**Additional Information in Respect of Application
to Discharge Condition 3 of Planning Permission
APP/N4205/W/21/3274951 Addition of a Concrete
Area, HGV Parking Area, Offices and Extension to
Existing Maintenance Sheds**

Pilkington Quarry, Horwich, Bolton BL6 6RS

January 2024

Plan No.
AA/PIL/HGV/01rev1

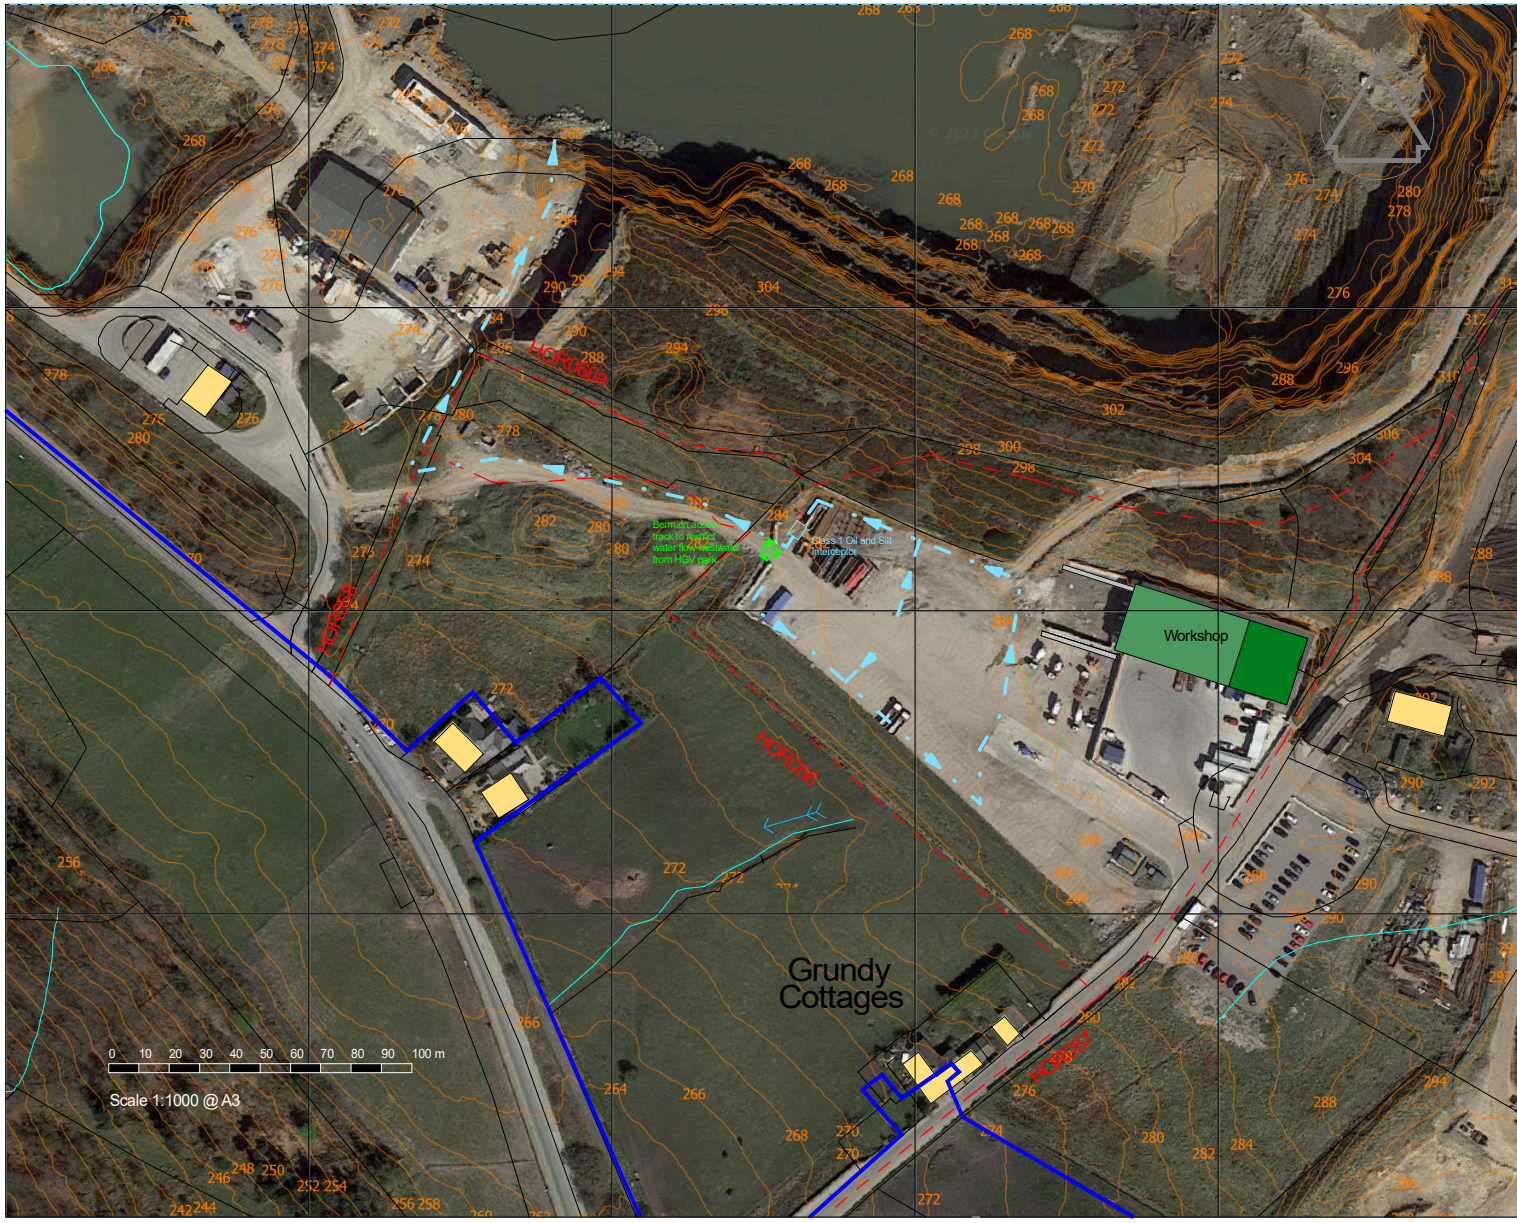
The Council's Drainage Officers have advised that the submitted scheme cannot be approved and therefore another solution needs to be proposed. They state that the drainage solution will need to comply with the requirements of the NPPF and DEFRA's Sustainable Drainage Systems: non-statutory technical standards. A detailed design would need to be submitted to how the proposal meets these standards. Officers have advised that the document submitted for this discharge of condition application only addresses a small part of the site: the main issue that needed to be addressed was uncontrolled run-off from the development and the HGV parking area in a westwards direction. This run-off was at one time flooding the public right of way and affecting the watercourse at Grundy Cottages, Makinson Lane, and therefore it needs to be shown how this will be adequately controlled: this run-off is not discussed in the submitted document.

- 3.16 The Drainage Officer's comments into the submitted scheme stated that "*the main issue that needed to be addressed was uncontrolled run-off from the development and the HGV parking area in a westwards direction. This run-off was at one time flooding the public right of way and affecting the watercourse at Grundy Cottages, Makinson Lane*"
- 3.17 Grundy Cottages on Makinson Lane are located to the east of the HGV parking area and the parking area rises up towards Makinson Lane. It is therefore suggested that the cottages are those on George's Lane to the south west of the HGV parking area.
- 3.18 It is understood that there was a 'drainage' event 2 to 3 years ago when works were done to the new internal access road linking Montcliffe Quarry to Pilkington Quarry. There was standing water on the access lane, which was allowed to run down towards the cottages. Since then, there

Revision	Date	Change
Rev 1	Jan 24	Inclusion of berm on internal access track to west of HGV park

- 3.20 To ensure all surface water run-off within the HGV the park is controlled and discharged by the drainage scheme to the lagoon, a small berm will be created along the western edge of the HGV park. This will inhibit the flow of water along the access road. The berm will only need to be approximately 200mm in height to ensure surface water within the HGV park cannot flow westwards along the track.

- 3.21 The location of the proposed berm is shown on Drawing AA/PIL/HGV/01 rev 1, provided in Appendix 2.
